**PLANNING DEPARTMENT ADMINISTRATIVE PUBLIC HEARING  
SUMMIT COUNTY, UTAH  
March 19, 2026**

# Planning Department Staff Report

**Subject:** 954 Woodside Avenue  
**Application:** PL-26-06828  
**Author:** Nan Larsen, Senior Planner  
**Date:** March 19, 2026  
**Type of Item:** Administrative Conditional Use Permit

**Subject:** 384 Woodside Avenue  
**Application:** PL-25-06388  
**Author:** Elissa Martin, Planning Project Manager  
**Date:** March 19, 2026  
**Type of Item:** Historic District Design Review

**SITE PLAN**  
1/8" = 1'-0"

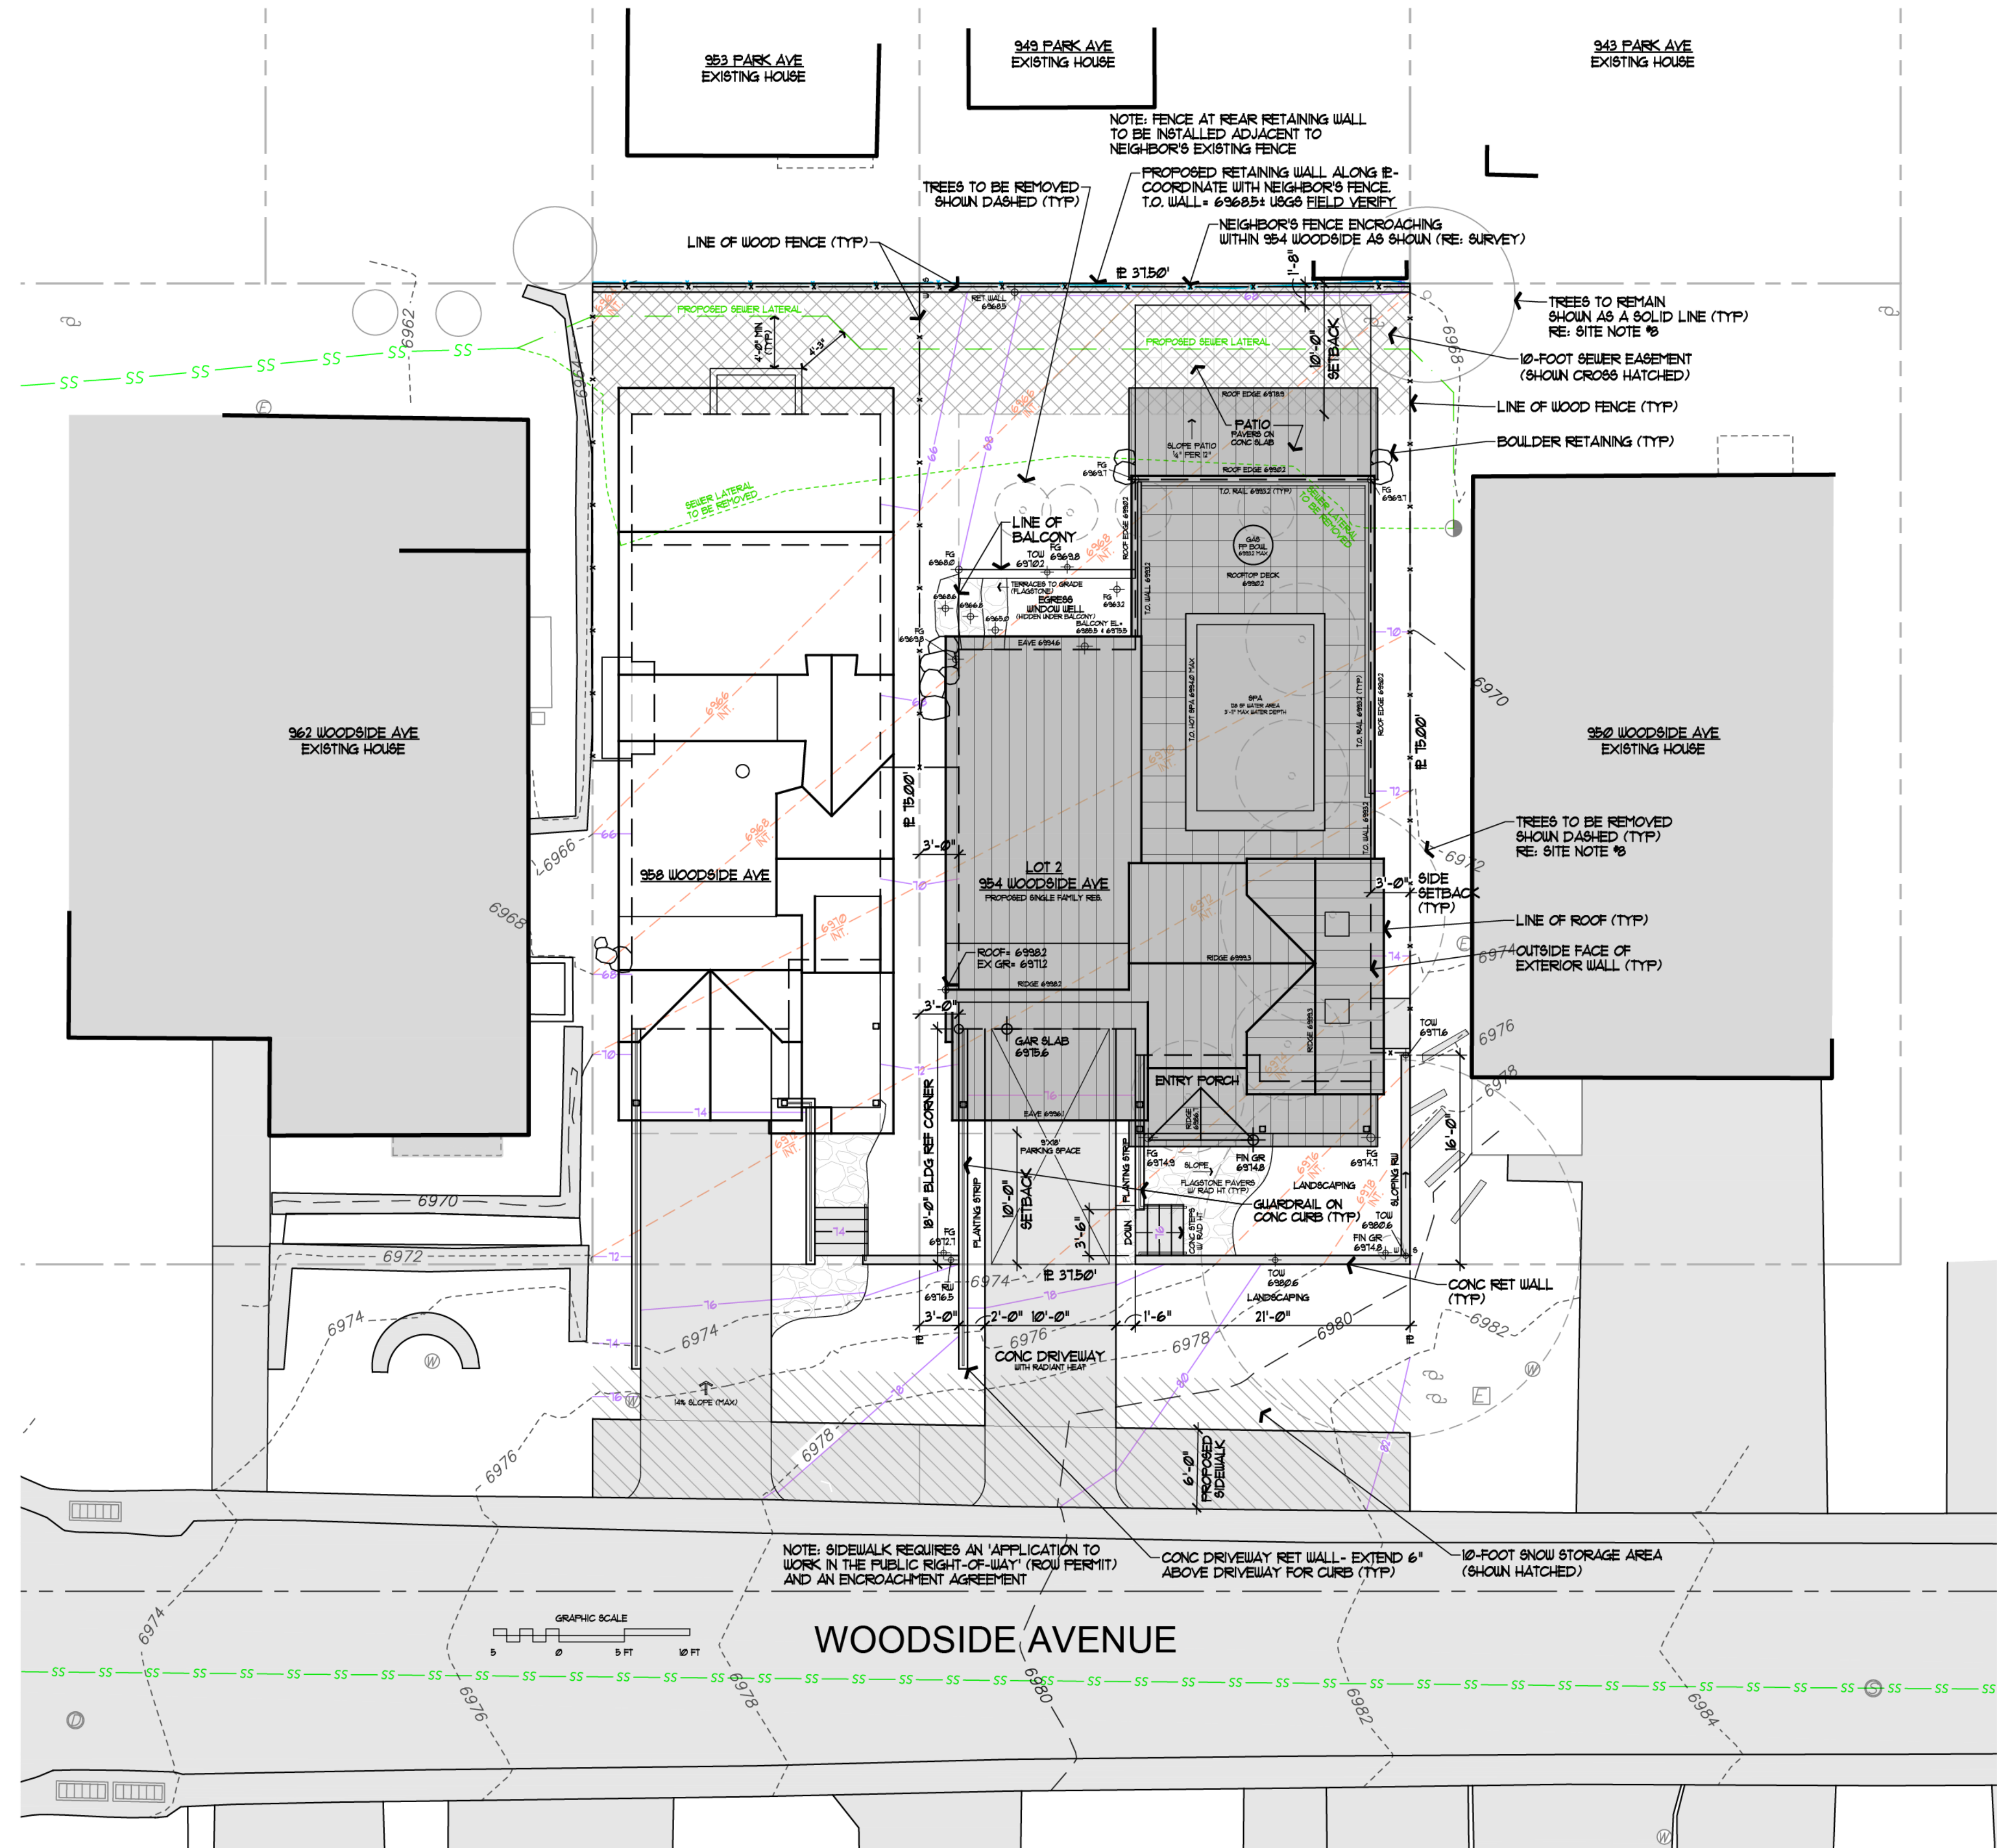
The exposed portion of the front retaining wall will be approximately 5'-10" tall as viewed from the yard, and 7" to 33" tall as viewed from the street. The side wall connects to the front wall at 5'-10" and slopes down to 3'-0". The walls will be constructed of board-formed concrete, with the walls and associated footings being contained entirely within the property.

Landscaping consisting of drought-resistant, perennial shrubs, grasses and trees will be planted between the front wall and street to visually buffer the walls.

1. Final building plans and construction details shall reflect substantial compliance with the plans approved March 19, 2026, by the Planning Director. Any changes, modifications, or deviations from the approved design and placement that have not been approved in advance by the Planning and Building Departments may result in a stop work order.
2. The Applicant shall obtain a Building Permit for the retaining wall and complete Engineering Department review for the retaining wall prior to construction.
3. Drainage behind the new retaining wall shall be maintained such that storm water runoff drains away from the wall to abate retaining wall failure.
4. Landscaping to visually screen the retaining wall from the public Street will consist of perennial shrubs, grasses, and trees.

Figure 1: Excerpt from Applicant's plans with staff's measurements of the garage

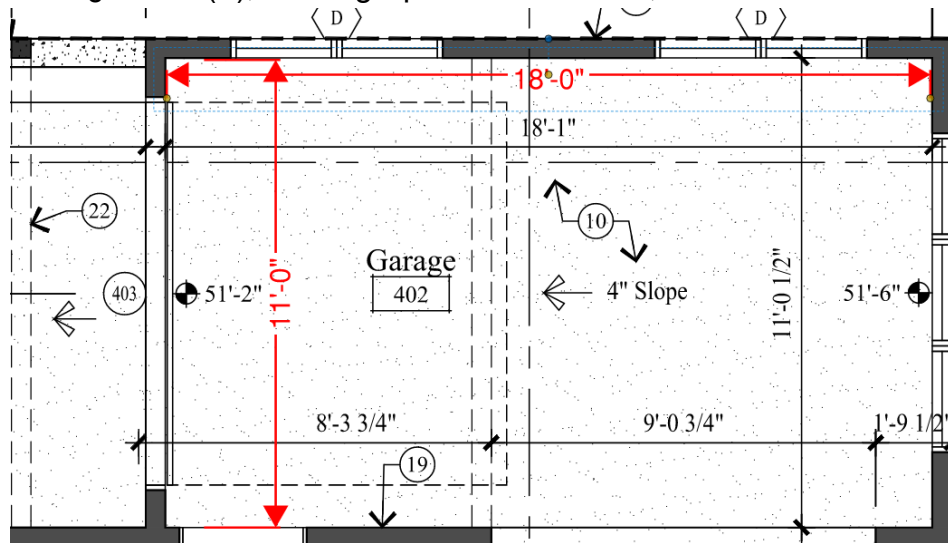
- c) The Applicant proposes a tandem parking configuration with the second required Parking Space in a single-car garage that has a Building Height of 32 feet, 2 inches from Existing Grade for the north gable end of the garage. The proposed garage exceeds the 27-foot Zone Height, by five feet, two inches.
- d) The Applicant's plans show the garage has a depth of 18 feet, which meets the HR-1 requirement according to the Building Height Exception for Garages on a Downhill Lot, which states the depth of the garage shall not exceed the minimum depth for internal Parking Space(s), pursuant to LMC § 15-3-3(F), Parking Space Dimensions, which is 18 feet in depth.
